CORPORATION
Crystal River Unit 3
Docket No. 50-302
Operating License No. DPR-72

Subject: License Amendment Request #256, Revision 0
Extension of Containment Sump Monitor Channel Calibration Interval

LICENSE AMENDMENT REQUEST #256, REVISION 0

**Extension of Containment Sump Monitor
Channel Calibration Interval**

Figure 1
Containment Sump Monitor Instrumentation String

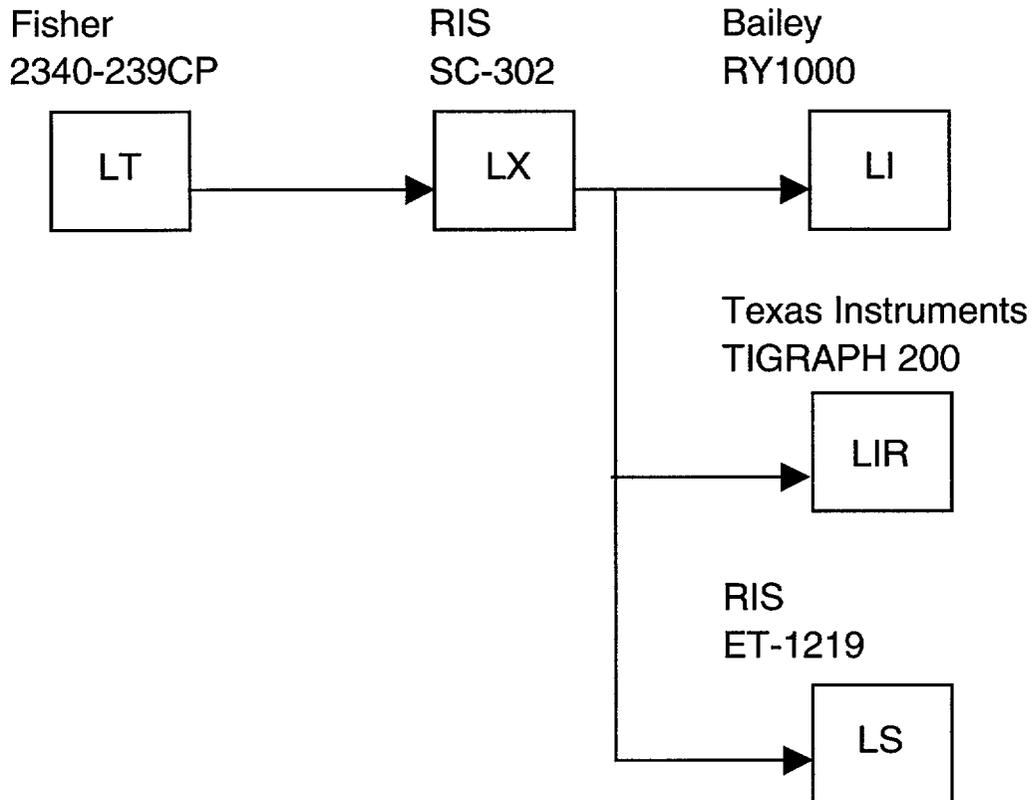
The containment sump level instrumentation is used to detect trends and changes in the sump level rather than an absolute level. The containment sump monitor instrumentation string, including the level transmitter, signal converter, level indicator, level recorder, and level switch are shown schematically in Figure 1.

The change in sump level is a possible indication of RCS leakage. The leak rate can be calculated based on the containment sump level as recorded on a recorder in the main control room. Therefore, although the actual level is recorded, only the trend is used to determine the leak rate into the sump. Any drift associated with the instrument over the trend period (one hour to one 12-hour shift) would be negligible.
